Changes in topside tank configurations that you need to know going forward!!

The new EPA Evaporative Emissions Regulations require Moeller as a fuel tank manufacturer to make several changes to our above deck topside tanks above 12-gallon in capacity to accommodate boats built after 2011:

031615 / 031615BR

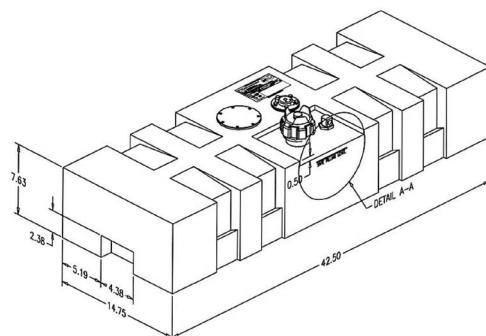
- Each Moeller tank must have a minimum of 5% of the inside volume reserved for ullage open headspace and thus a full fill line is molded in to each tank.

- Tank capacities now reflect the required inside 5% open headspace requirement for both EPA and non-EPA tank models.
- A NEW EPA compliant 2-stage “click when closed” fuel cap is required for the ‘BR’ (Barrier version) model tanks as well.

- Moeller utilizes the same mold lid/base for barrier and non-barrier versions thus we have had to install a 3” port in the center of the tank to allow for the barrier material to be loaded during production.

- Replacing the old style Kelch gauge/cap eliminates the ability to have a sight gauge on the barrier version models thus we install a 1-1/2” block off plate in the non-barrier version tank models so we can install a mechanical float gauge in the barrier version models.
